Ref: SSD-24299707
WTJ21-203

WILLOWTREE PLANNING

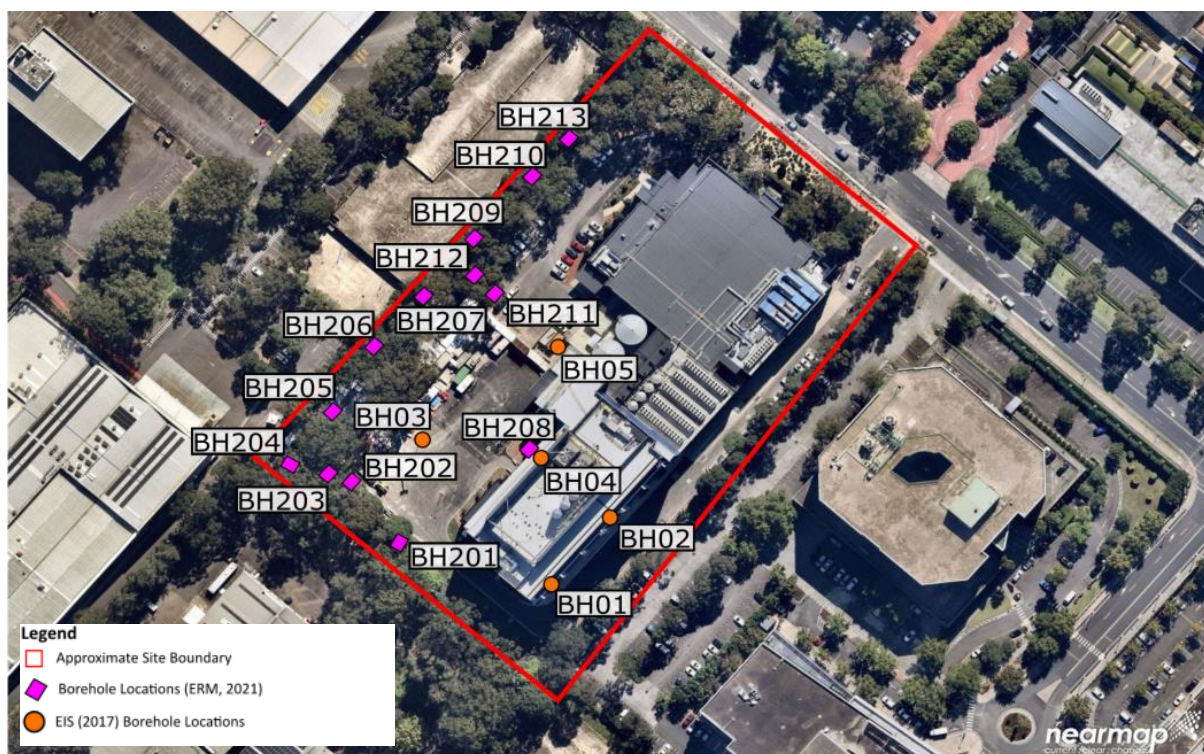
- The site can be made suitable for the intended land use, consistent with 'Commercial / Industrial' as defined in the National Environment Protection (Assessment of Site Contamination) Amendment Measure 2013 (No. 1) ('NEPM', NEPC, 2013), following the excavation, classification and disposal of asbestos impacted fill materials from location BH207_0.3 (refer below).
- If any unexpected finds of potentially contaminated material is uncovered during excavation, or material observed to be different to the material described in the DSI Addendum report is encountered, then these materials should be excavated separately and assessed by a contaminated land professional.
